Wisconsin Department of Transportation

Proposal #1: 1030-20-84, WISC 2018 380
N-S Freeway
South Milwaukee Roadway/Mainline
IH 94
Milwaukee County

Letting of July 24, 2018

This is Addendum No. 02, which provides for the following:

Addendum No. 02
 ID 1030-20-84
 Revised Sheet 189
 July 11, 2018

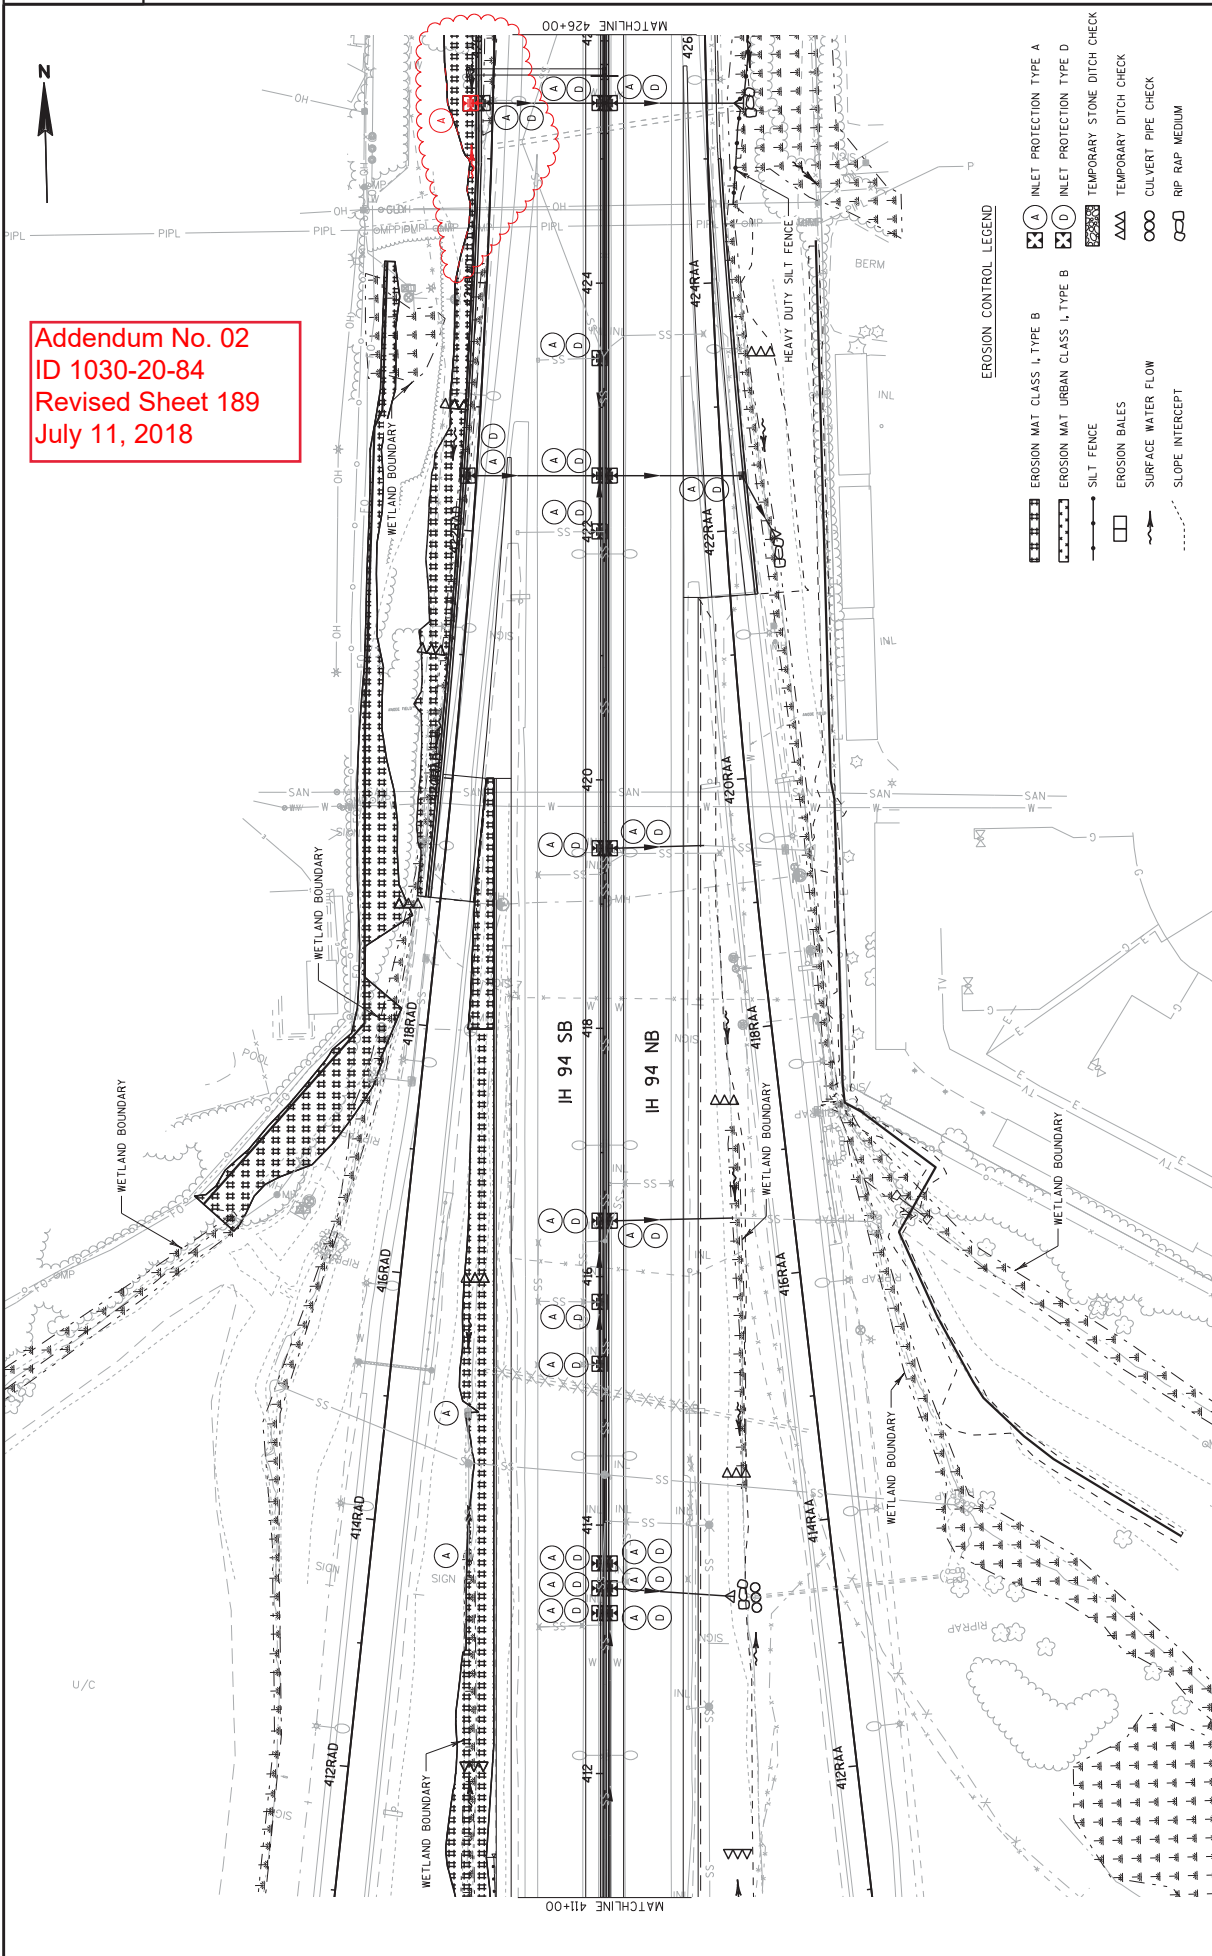
ID 1030-20-84 Revised Plan Sheets	
Plan Sheet	Plan Sheet Title (brief description of changes to sheet)
189	Erosion Control - Stage 1 and 2 - Added inlet protection for new inlet 305A and adjusted erosion mat based on revised slope intercepts
237	Storm Sewer - Added inlet 305A to eliminate ditch at West Shore Pipeline crossing
238	Storm Sewer - Added inlet 305A to eliminate ditch at West Shore Pipeline crossing

Addendum No. 02
 ID 1030-20-84
 Revised Sheet 1085
 July 11, 2018

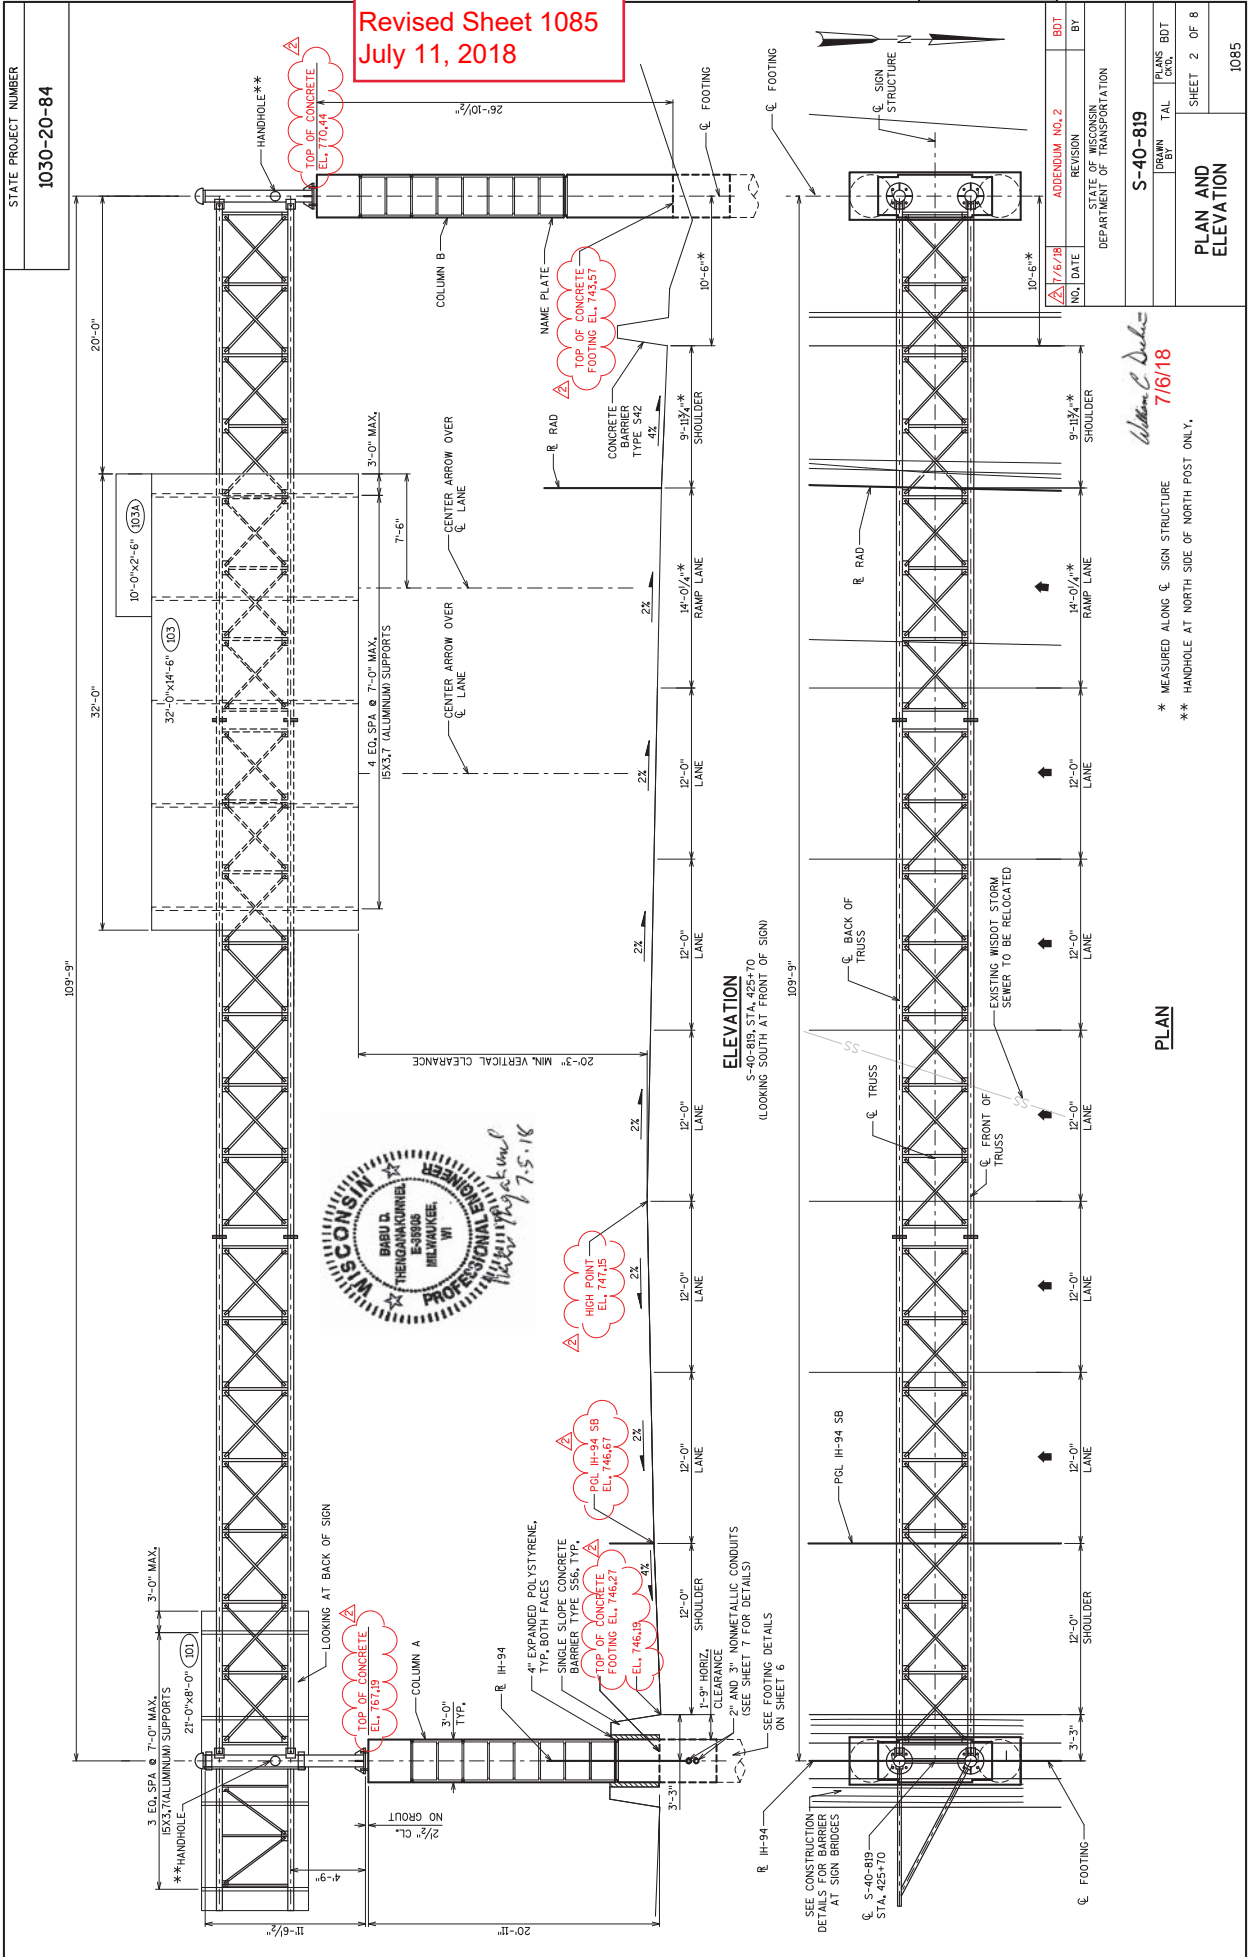
581	Miscellaneous Quantities - Updated earthwork summary for revised ditch at new inlet 305A, deleted note regarding wasting EBS off site
605	Miscellaneous Quantities - Added inlet 305A
612	Miscellaneous Quantities - Added pipe from inlet 305A to inlet 306
628	Miscellaneous Quantities - Added inlet protection for inlet 305A
709	Plan and Profile: IH 94 - Revised slope intercept at revised ditch at new inlet 305A
710	Plan and Profile: IH 94 - Revised slope intercept at revised ditch at new inlet 305A
722	Plan and Profile: IH 94 - Revised slope intercept at revised ditch at new inlet 305A
967	Structure Plans- B-40-806-General Plan & Elevation- Added 2 year storm information
980	Structure Plans- B-40-806-South Structural Approach Slab- Revised approach slab width dimension
989	Structure Plans- B-40-807-General Plan & Elevation- Added 2 year storm information
1085	Structure Plans- S-40-819-Plan and Elevation- Revised elevations

Addendum No. 02
ID 1030-20-84
Revised Sheet 1089
July 11, 2018

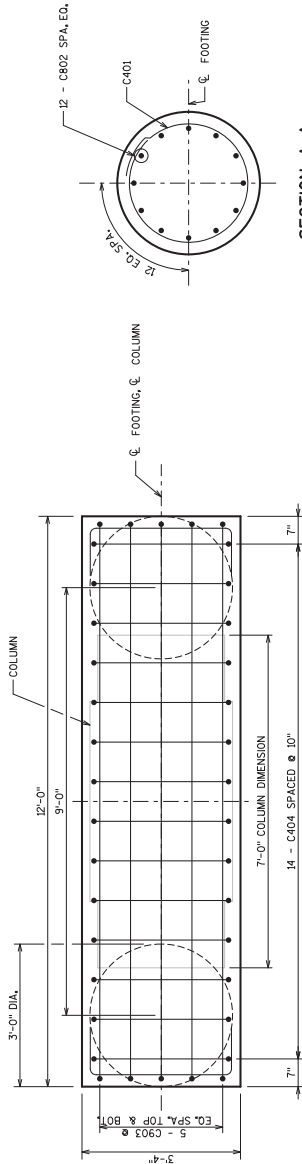
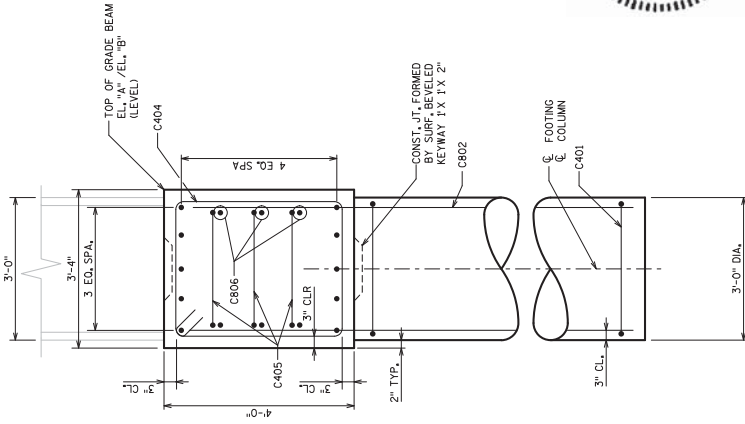
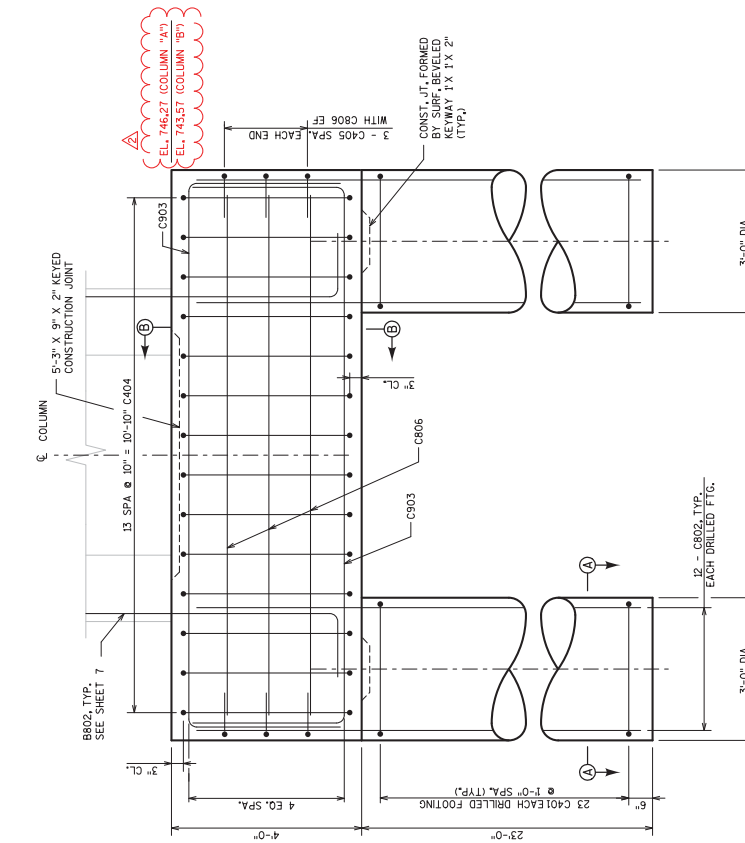
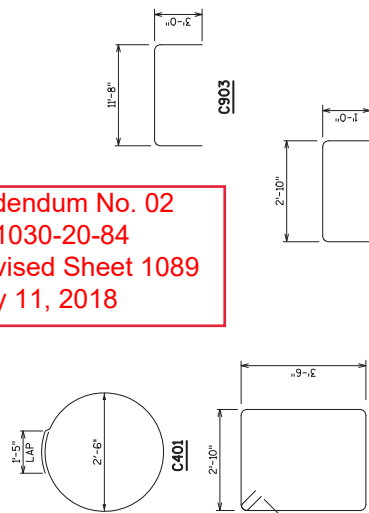
1089	Structure Plans- S-40-819-Concrete Foundation- Revised elevations
1090	Structure Plans- S-40-819-Concrete Column and Reinforcement Details- Revised elevations
1112	Earthwork - Updated earthwork for revised ditch at new inlet 305A
1113	Earthwork - Updated earthwork for revised ditch at new inlet 305A
1479	Cross Sections: IH 94 SB - Revised ditch at new inlet 305A

Addendum No. 02
ID 1030-20-87
Revised Sheet 217
July 11, 2018

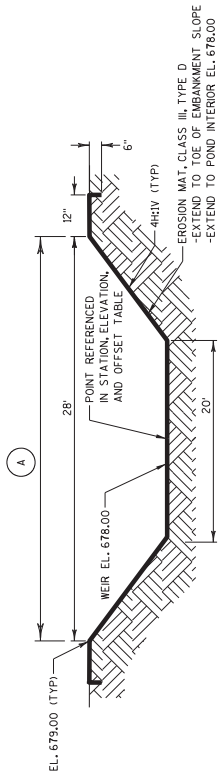
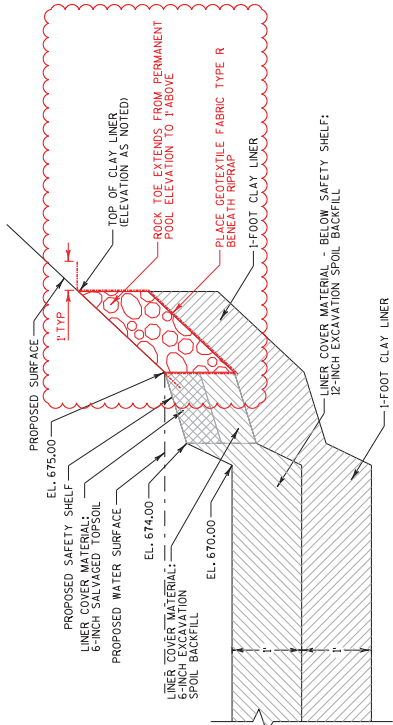
ID 1030-20-87 Revised Plan Sheets	
Plan Sheet	Plan Sheet Title (brief description of changes to sheet)
217	Southeast Wet Detention Pond (Added Rock Toe)
218	Southeast Wet Detention Pond (Added Rock Toe)
220	Northwest Wet Detention Pond (Added Rock Toe)
221	Northwest Wet Detention Pond (Added Rock Toe)
362	Miscellaneous Quantities (Revised Note 2 on Earthwork Summary)
707	Structure Plan B-40-800 - General Plan & Elevation (Cofferdam limits extended)
709	Structure Plan B-40-800 – Quantities and Profile Grade Lines (Concrete quantity revised)
742	Structure Plan B-40-801 – Quantities and Profile Grade Lines (Concrete quantity revised)
776	Structure Plan B-40-802 – Quantities and Profile Grade Lines (Concrete quantity revised)

Addendum No. 02
ID 1035-01-72
Revised Sheet 94
July 11, 2018

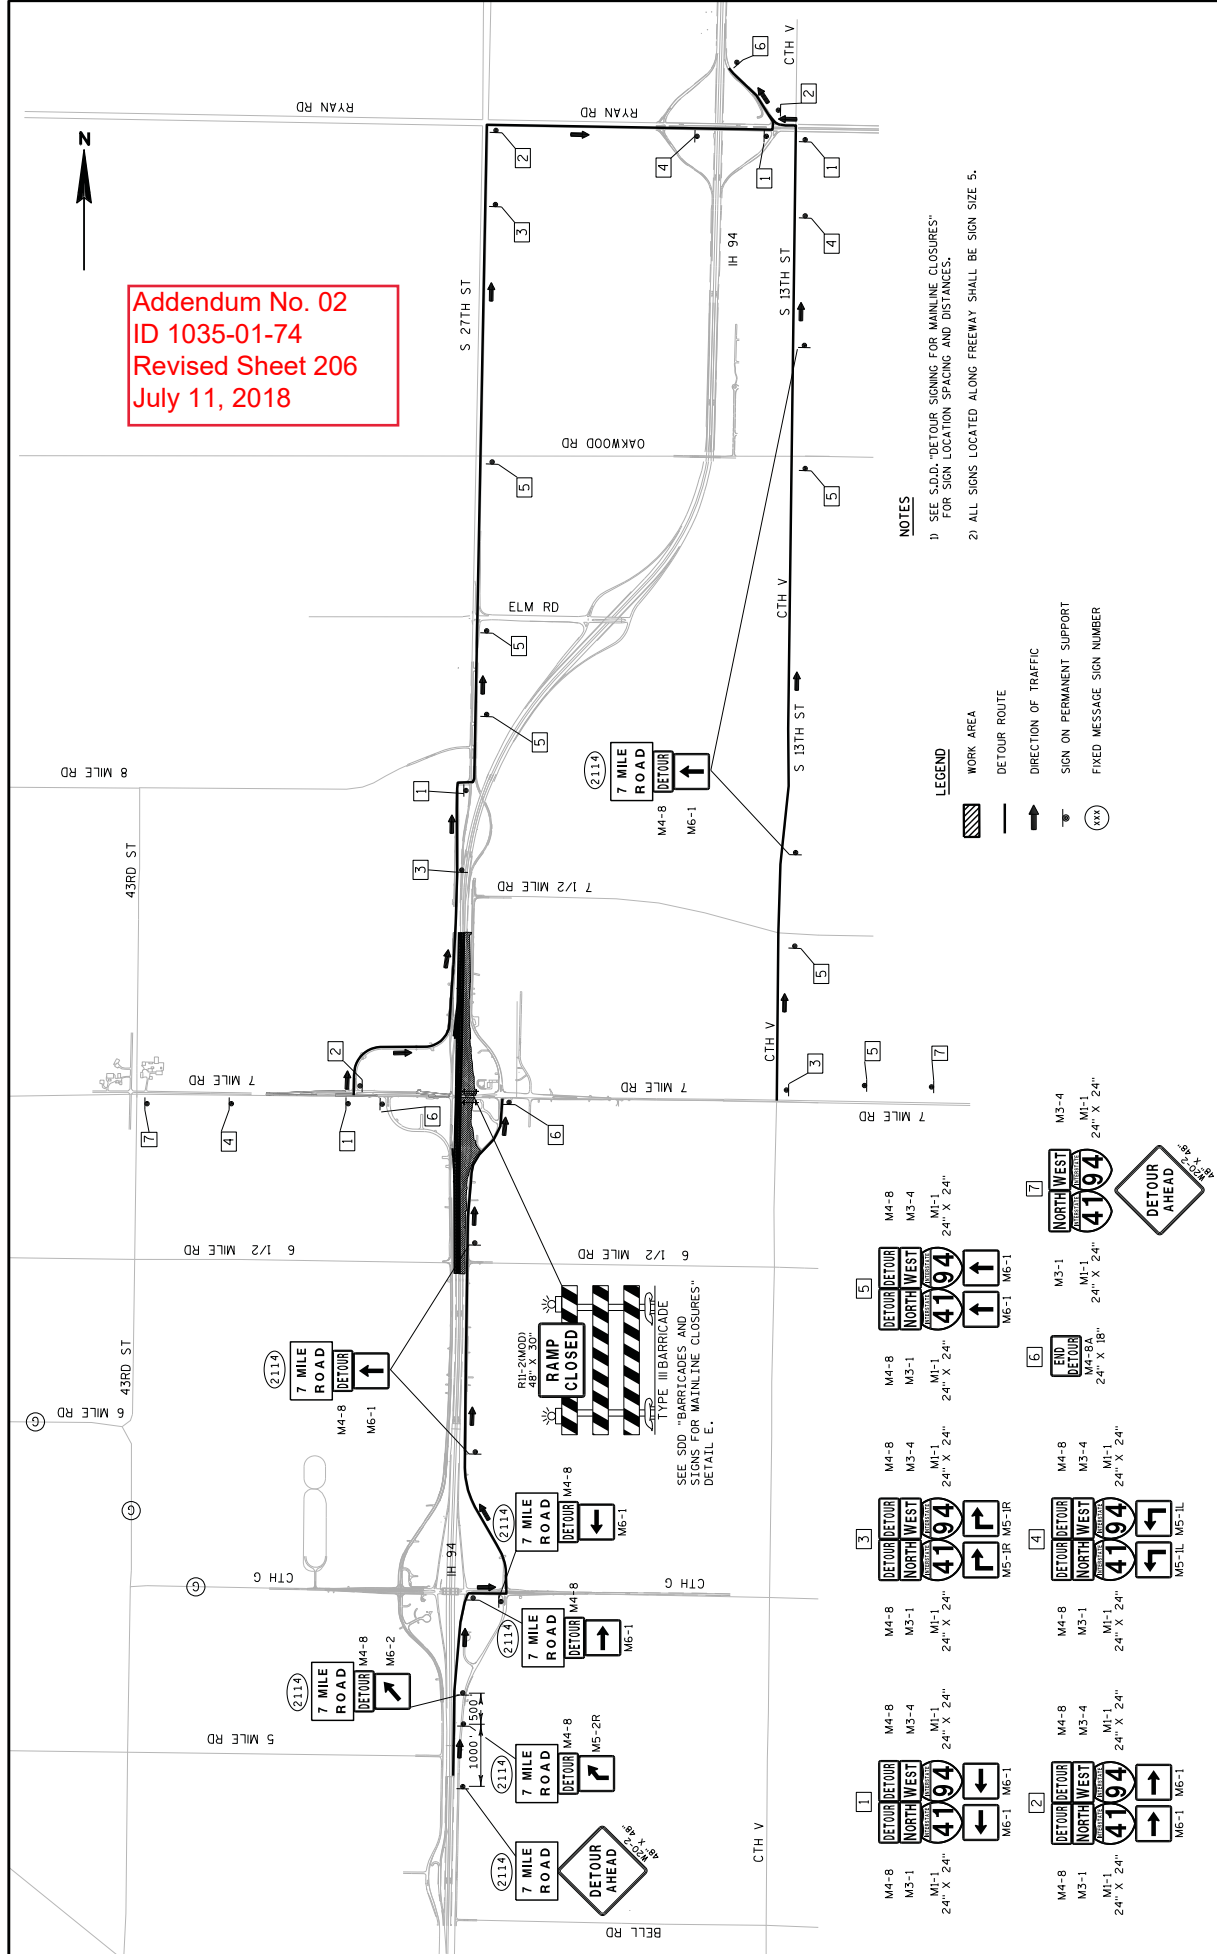
(ID 1035-01-72) Revised Plan Sheets	
Plan Sheet	Plan Sheet Title (brief description of changes to sheet)
94	Miscellaneous Quantities (Revised Note 2 on Earthwork Summary)
